Office Action Summary

10/804,022

TAGUCHI, TOMOKO

FIG. 1

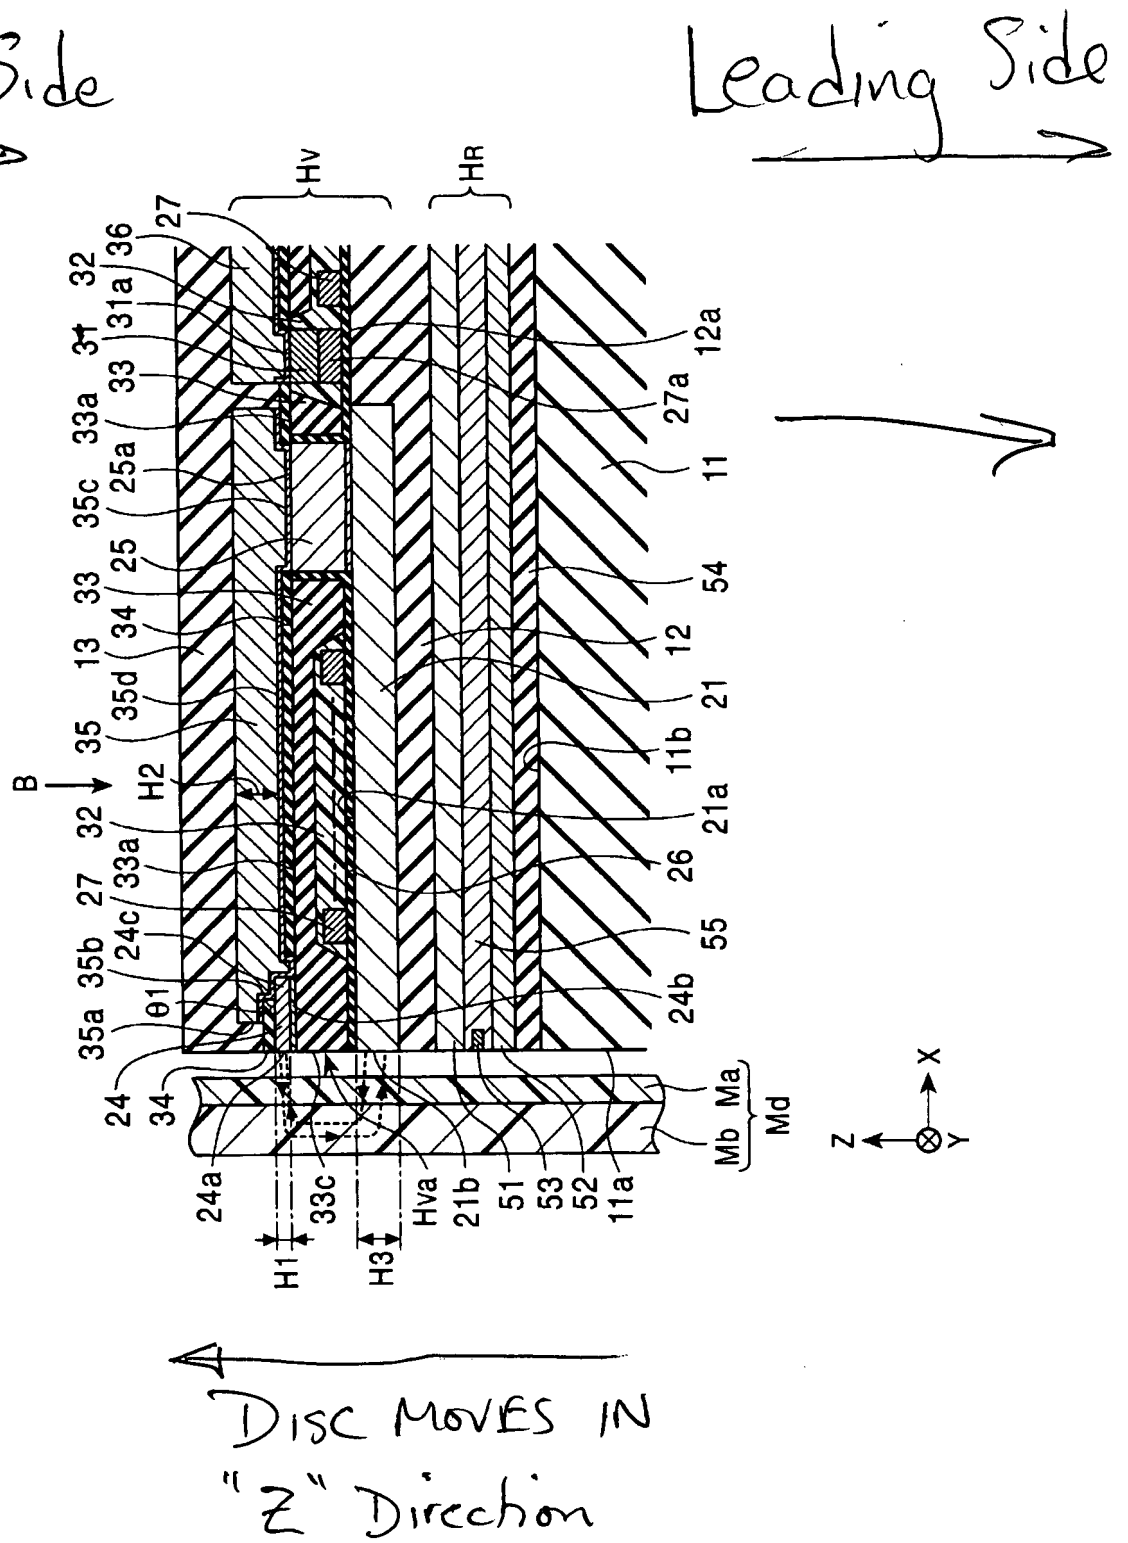
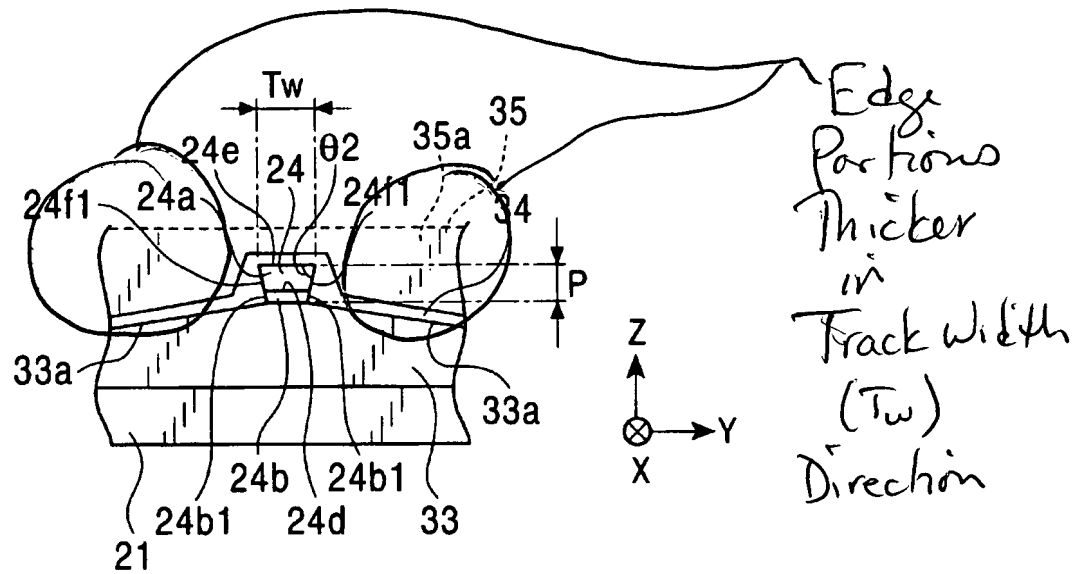
8. Claims 3-5 and 8-10 are rejected under 35 U.S.C. 102(e) as being anticipated by Sato et al (US 6,697,221).
9. Regarding Claims 3 and 8, Sato et al shows (Figs. 1-3) a perpendicular magnetic recording head, comprising: a double layered perpendicular recording medium (Md) comprising a soft magnetic underlayer (Mb) and a perpendicular recording layer, which are formed on a substrate (Ma); and a perpendicular magnetic recording head comprising a main pole (24) configured to generate a recording magnetic field in a perpendicular direction, and an auxiliary pole (21) connected to the main pole on a leading side to the main pole (see Examiner's Drawing- connected through portion 25 – highlighted area), and a write shield (13+35+34) arranged apart from the main pole on a trailing side to the main pole and having a multilayered structure in which a nonmagnetic layer (34) is sandwiched between magnetic layers (35 and 24 – see Figure 2).
